MEMORANDUM

Subject: CUP-24-1-Conditional Use Permit Request for drive-in restaurant in the GC-General Commercial zoning district on 1.02 acres at 1421 South Main Street (Tax Map Nos. 287-22 1-5 & 287-22 102-105) by Balzer and Associates, LLC (applicant) for Blacksburg Square, LLC (owner).

CUP-24-1 Request for drive-in restaurant in GC at 1421 South Main Street

**Seven Brew Application Addenda May 28, 2024:**

**A2.2**

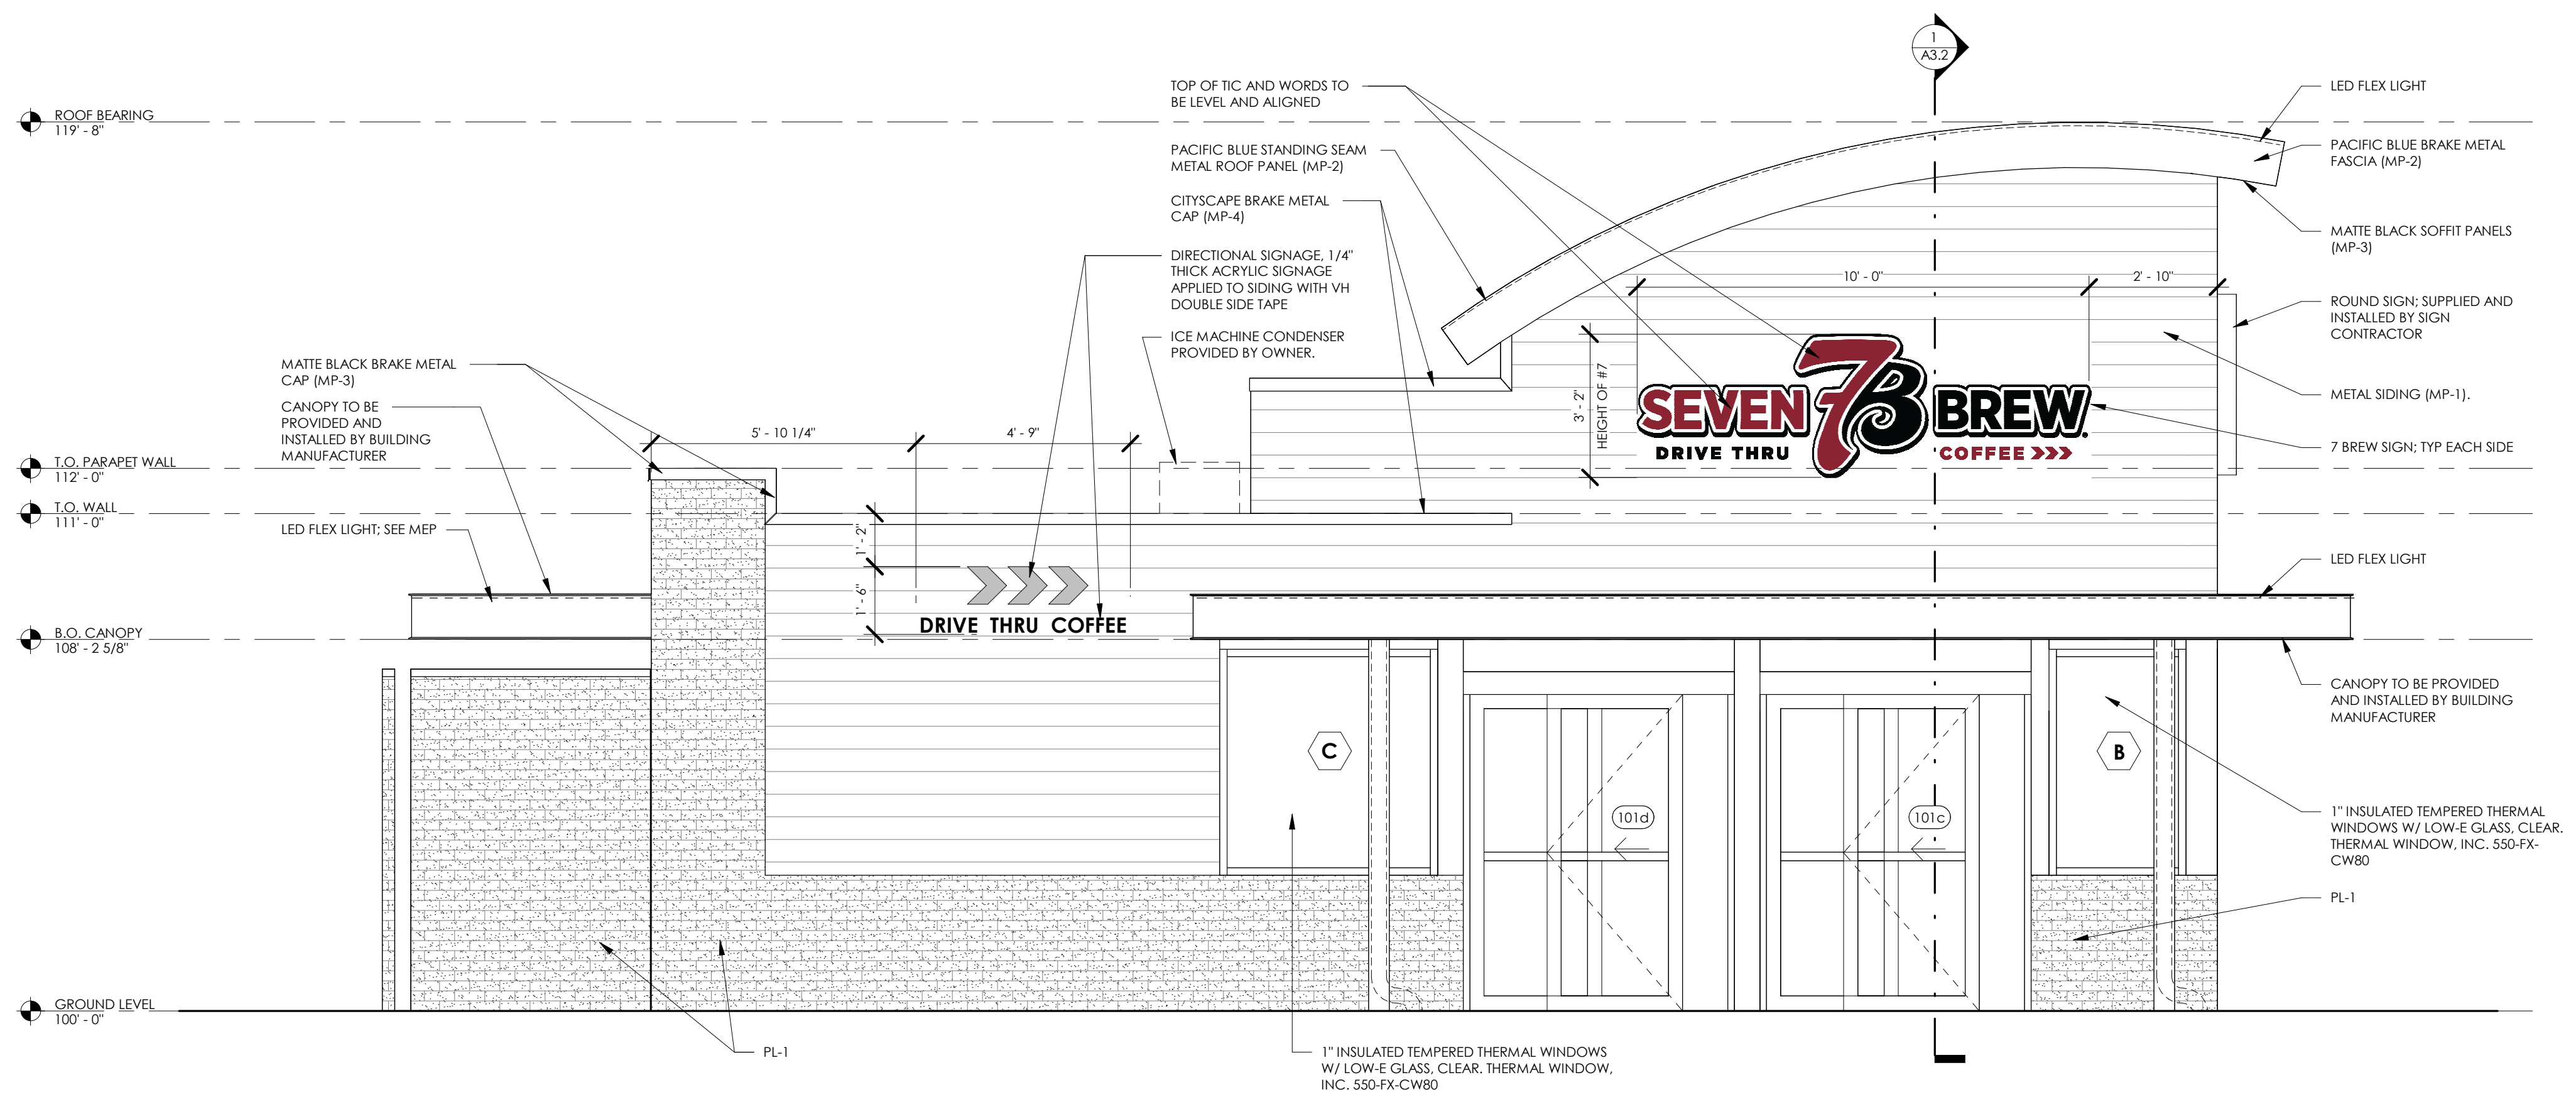
Staff showed the proposed signage that was provided with the application, and asked the applicant to provide dimensions of each façade to determine if the signage was in accordance with signage regulations in the zoning ordinance. The applicant provided those dimensions, and all business signage meets zoning ordinance standards. Though, the drawings show directional signs exceeding the size limit of 3 square feet. *The applicant should reduce the size of all directional signs to a maximum of 3 square feet.*
